P-15457-1

S4819

**JINDAL ALUMINIUM LTD.**  
BANGALORE-560073 (INDIA)

PARTY'S NAME	AEK TEK AUTO ENGINEERING PVT. LTD., LUDHIANA
PARTY'S DRAWING No.	AS PER SAMPLE & REQUIREMENT
ALLOY & TEMPER	6063 T6
DESCRIPTION	MISC. SECTION

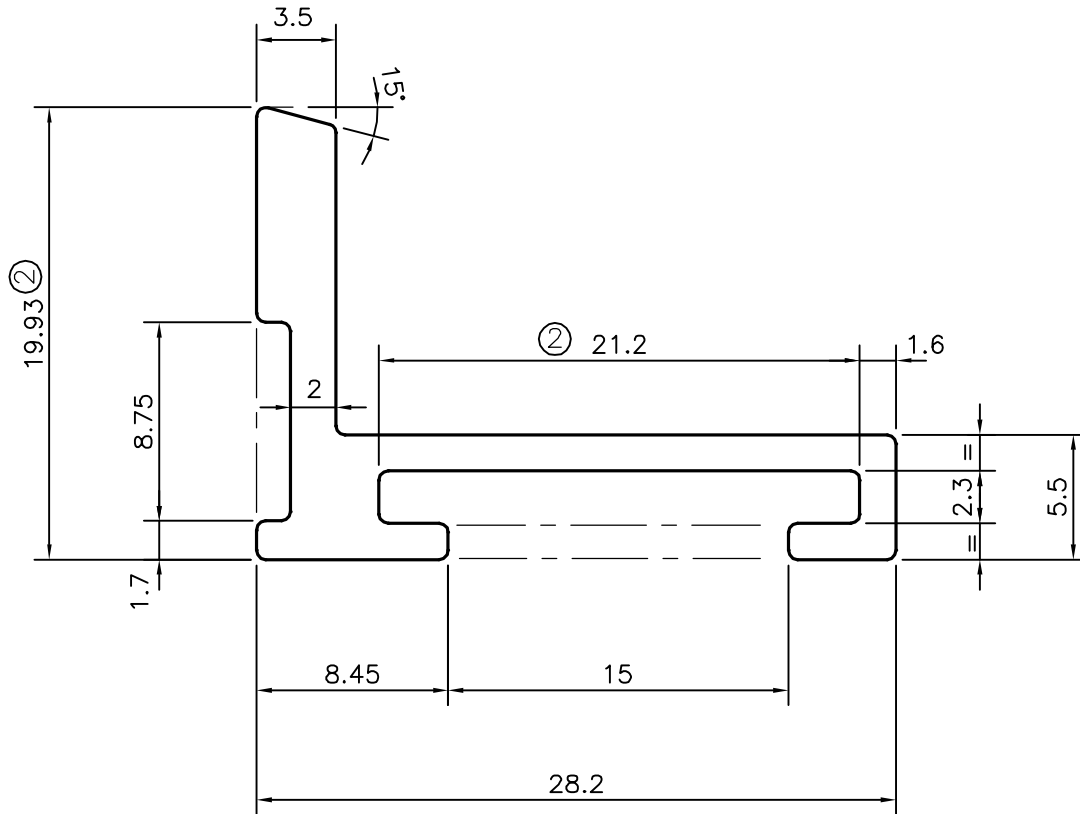
DIMENSIONS CHANGED FROM 17.9 TO 19.93 & FROM 22.2 TO 21.2  
WEIGHT ALSO CHANGED FROM 0.294 kg/m TO 0.320 kg/m
